# TECHNICAL BULLETIN

**[Issue No.]** T09-0012-A

**[Title]** Ethernet Interface Module

Changes to Specifications of TCP Maximum Segment Size Option Transmission  
(Revised)

## 1. TCP Maximum Segment Size Option Transmission

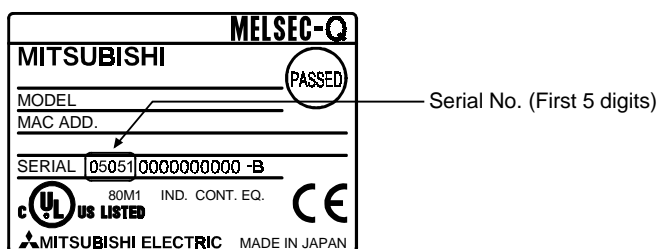
The Ethernet interface modules can enable the RFC-compliant TCP Maximum Segment Size Option transmission at the time of TCP transmission or retransmission.

1) MELSEC-Q series sample program

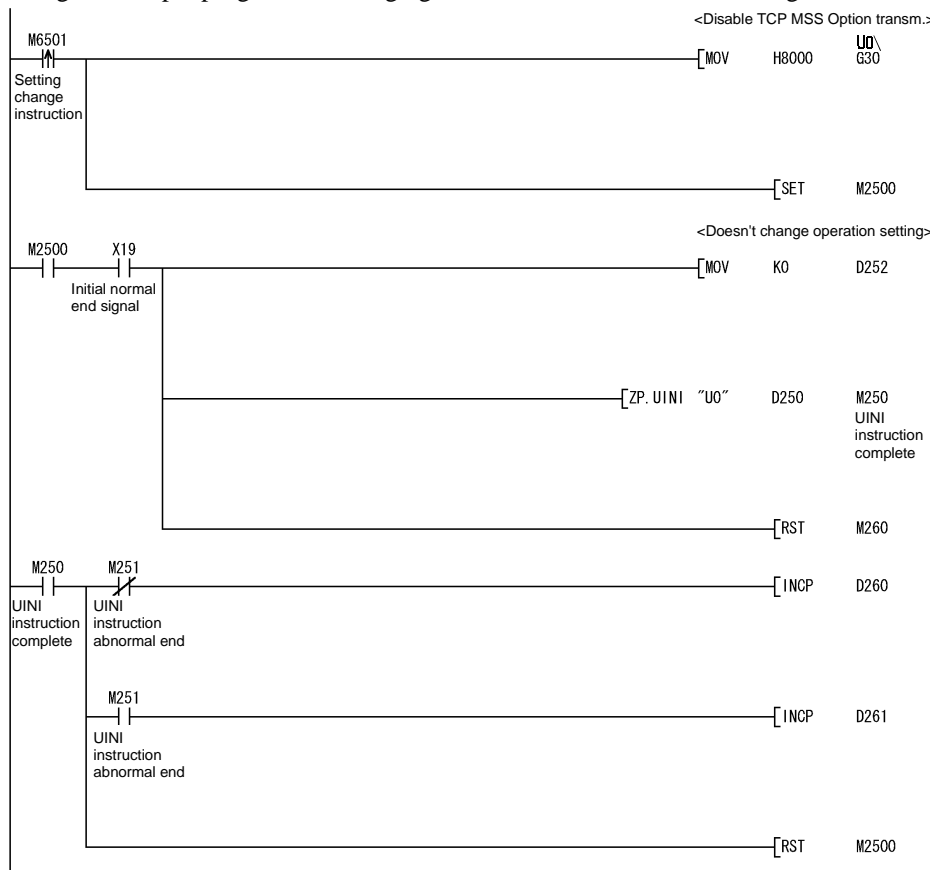
When changing between enable/disable for the TCP packet transmission, set a new value in the TCP Maximum Segment transmission setting area, buffer memory (Address: 1E<sub>H</sub>), and then reinitialize the module. (See Section 6. for the initial default value.) Re-initializing the module makes the changed setting effective.

The following is a sample program for changing to disable the TCP Maximum Segment transmission setting.

1) MELSEC-QnA series sample program

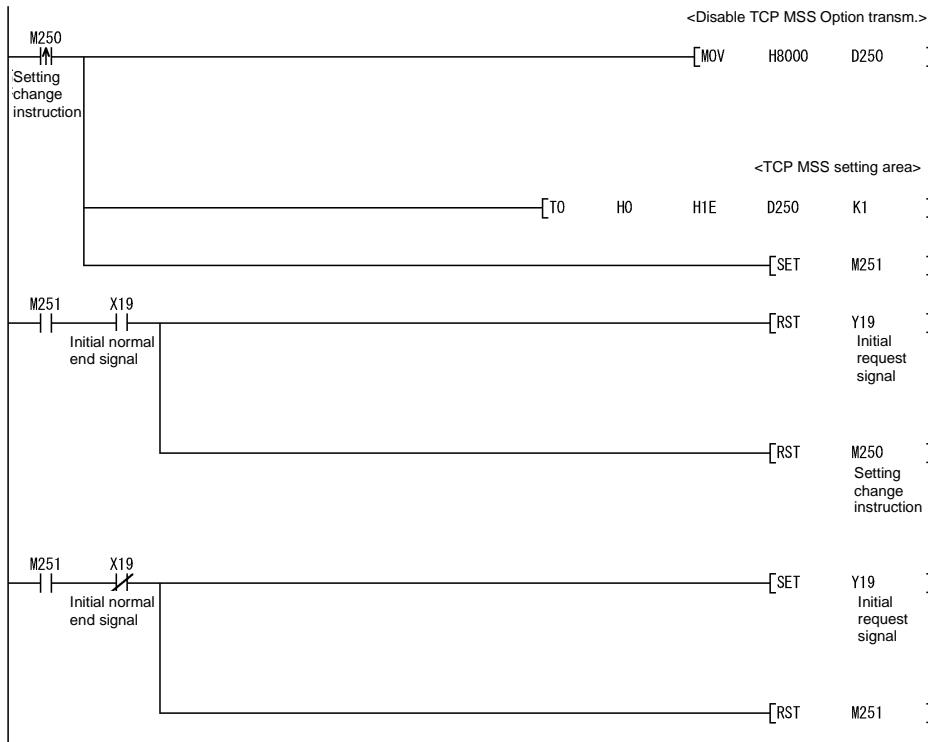
When changing between enable/disable for the TCP packet transmission, set a new value in the TCP Maximum Segment transmission setting area, buffer memory (QnA series address: 1E<sub>H</sub>, A series address: 06<sub>H</sub>), and then execute the re-initial processing. Re-initializing the module makes the changed setting effective.

The following is a sample program for changing to disable the TCP Maximum Segment transmission setting.

## 2) MELSEC-A series sample program

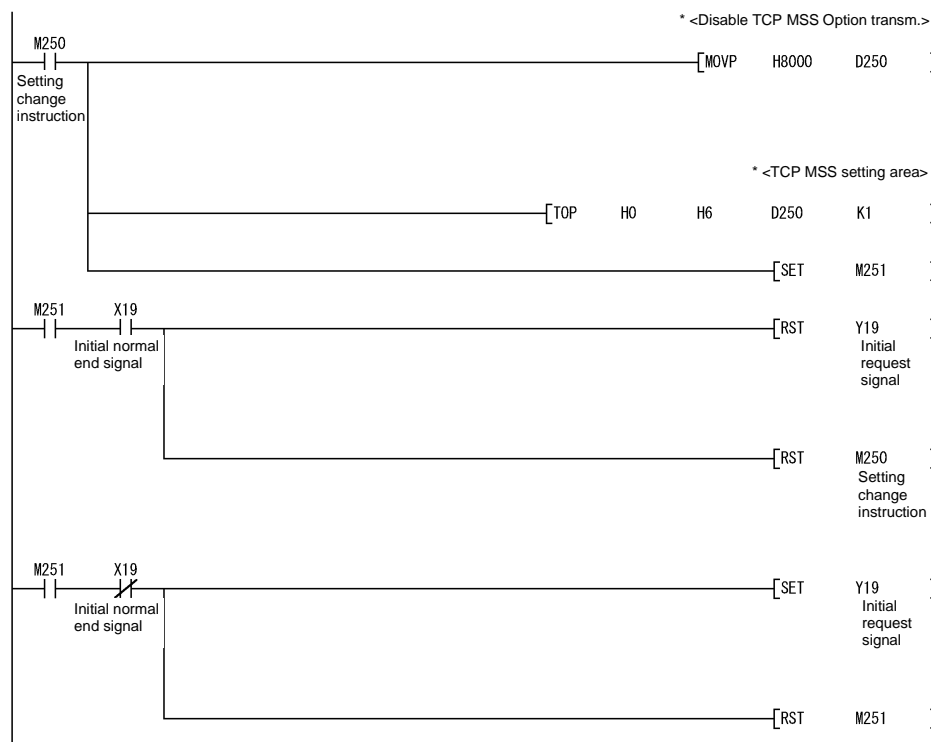
The following is a sample program for changing to disable the TCP Maximum Segment transmission setting.

**4. Reception processing on the Transmission Target End (Precautions)**

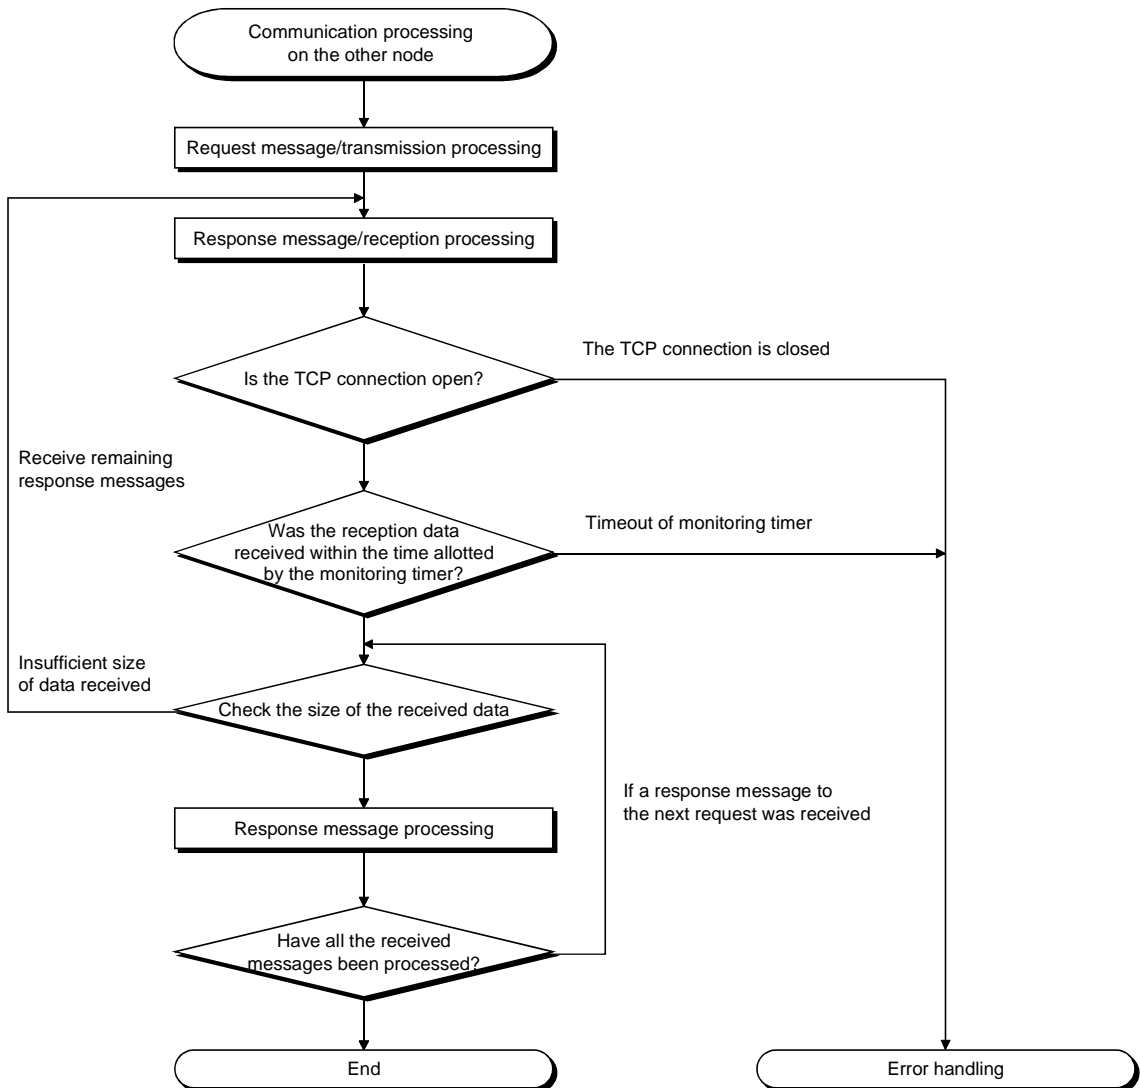
When “Enable TCP Maximum Segment Size Option transmission” is set, the transmission target end (node) program must be as explained in the following Section (a).

- (a) Program processing on the transmission target end (node)  
The following is required.

- (b) When the transmission target does not support the receive processing flow chart shown in section 4 (a).  
If the transmission target does not support the receive processing shown in Section 4 (a), the following results will occur when communicating with the “TCP Maximum Segment Size Option transmission” is set to enable.
- Incorrect data read, when batch read is executed from the transmission target using MC protocol.
  - Incorrect data read, after replacing the Ethernet module (which does not support the TCP Maximum Segment Size Option transmission function) with the alternative module supporting the function.
  - Data is not received, even though the value of “Number of packet reception” area (Address: 1B8<sub>H</sub>, 1B9<sub>H</sub>) in the buffer memory was changed.
- If this occurs, change the setting “TCP Maximum Segment Size Option transmission” setting to disable
